Reference: BMK Unit V Expansion of the Hamilton Wetland Restoration Project

1 BEL MARIN KEYS UNIT V EXPANSION OF THE
2 HAMILTON WETLAND RESTORATION PROJECT
3 DRAFT SUPPLEMENTAL ENVIRONMENTAL IMPACT STATEMENT/REPORT
4 TRANSCRIPT OF PUBLIC COMMENT AT PUBLIC HEARING (8/21/02)
5

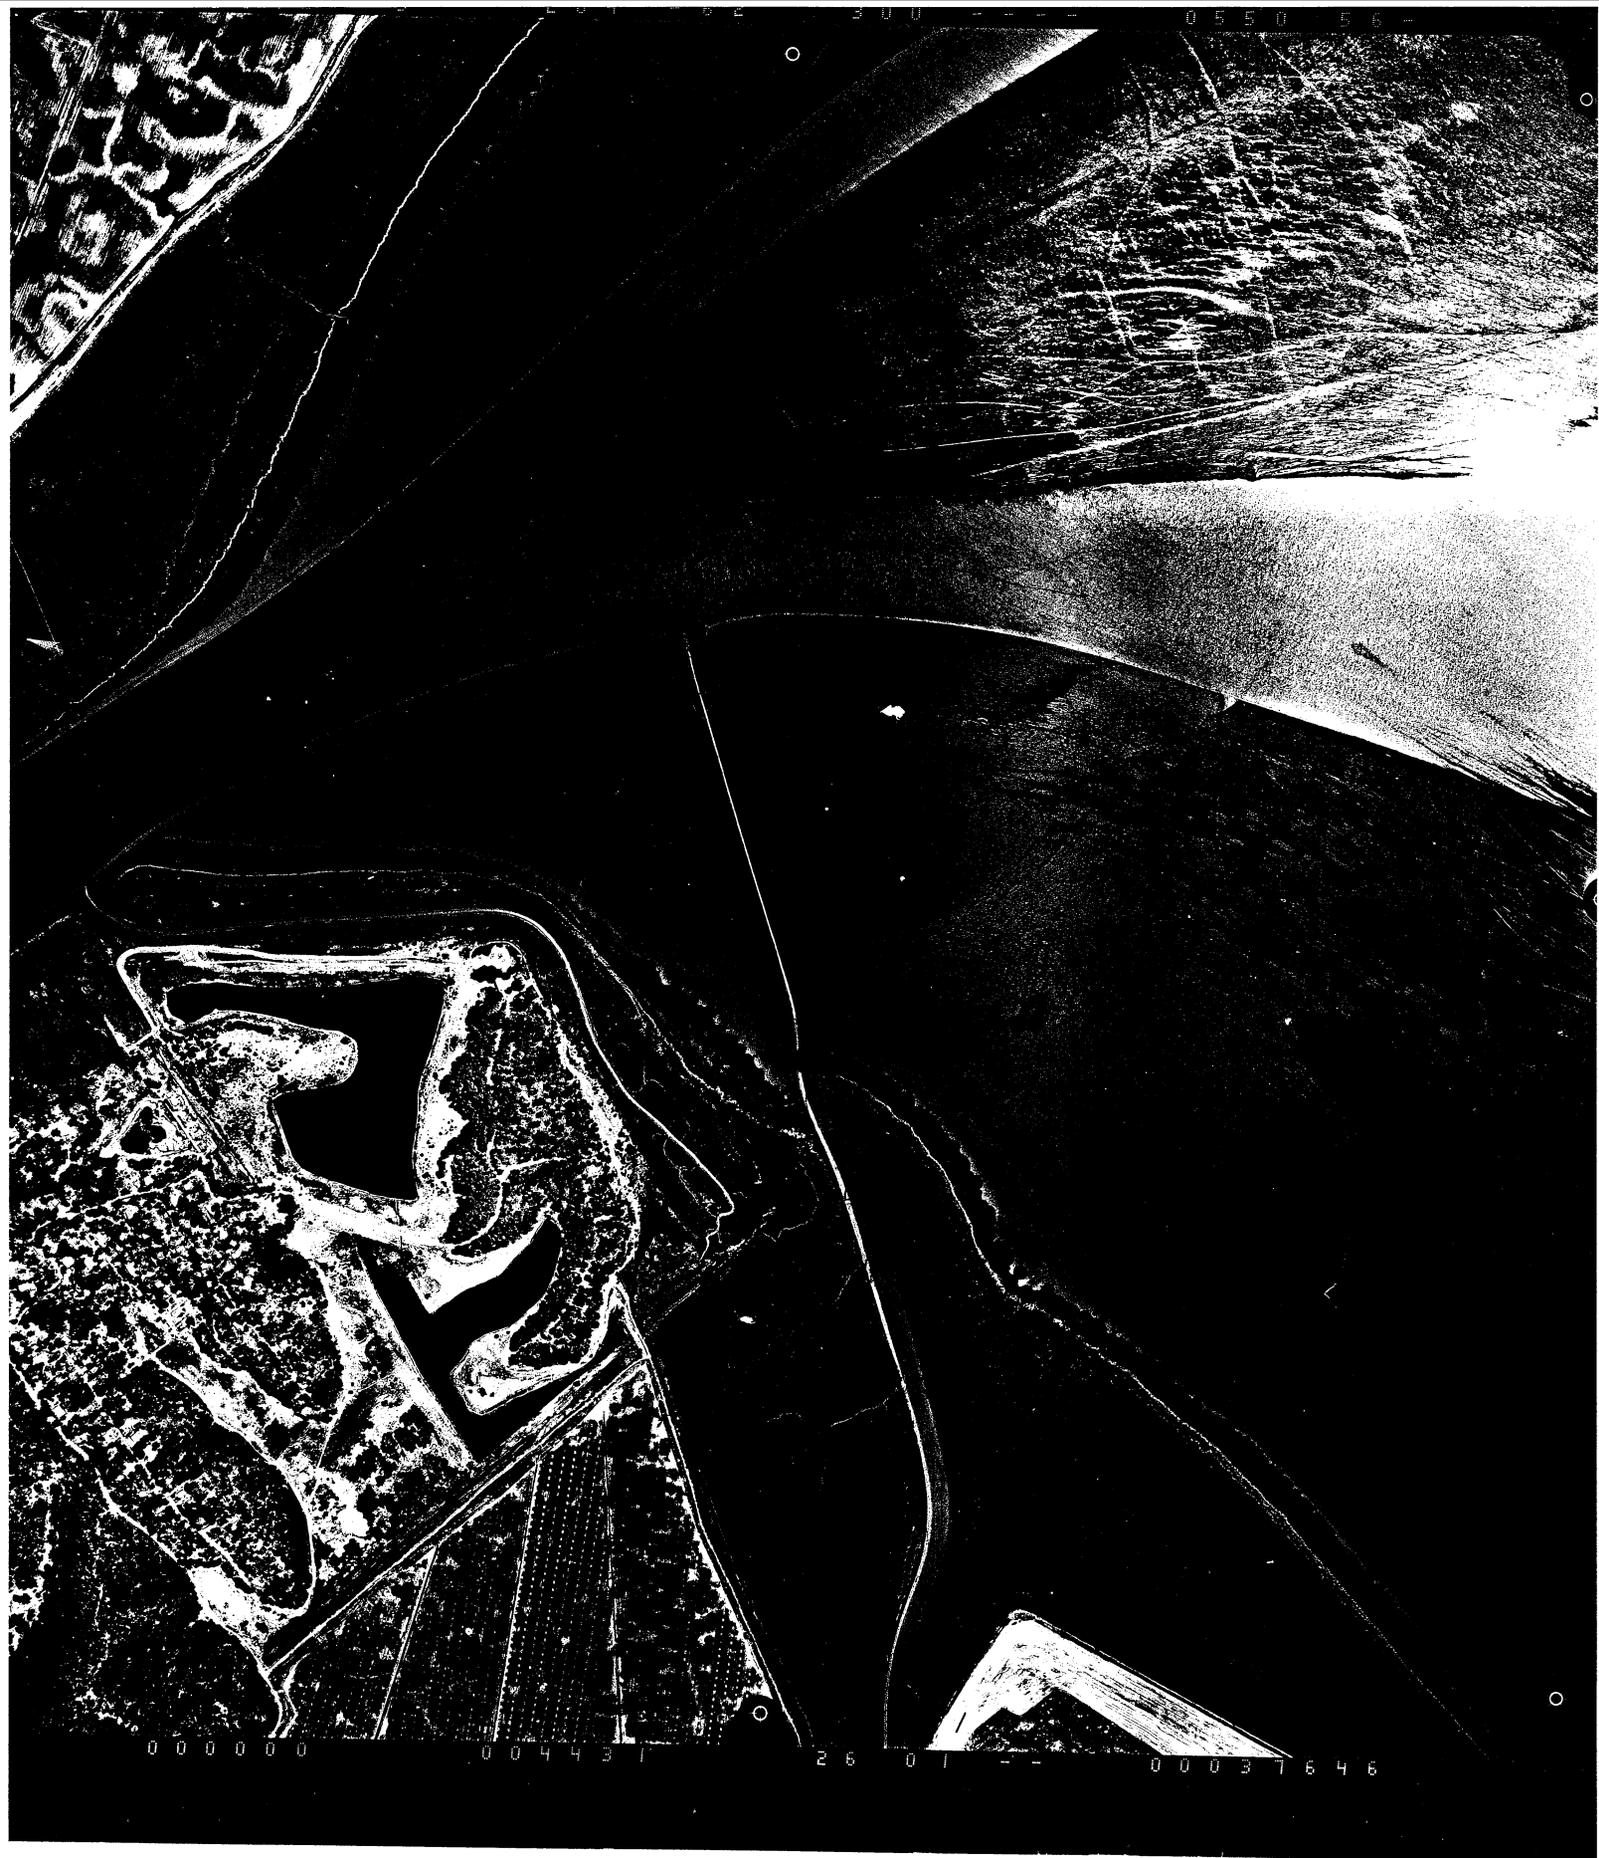
Your Draft EIR has not sufficiently addressed any significant changes to our outer navigable channel. Please illustrate how your proposed changes will affect this very important waterway.

Attached are aerial photos showing the Bel Marin Keys outer channel.

4
5 See Master Response 6 regarding Novato Creek morphology and Master Response 8 regarding
6 navigation.

7
8 The Krone report identifies optimum flushing procedures to provide scouring flows along the Novato
9 Creek channel to favor navigation of the channel. While these procedures may promote scour in the
10 channel, it is evident by the current planning by the BMK CSD to dredge Novato Creek that these
11 flushing procedures alone are insufficient, in absence of periodic dredging to maintain navigability all the
12 way to the Petaluma channel.
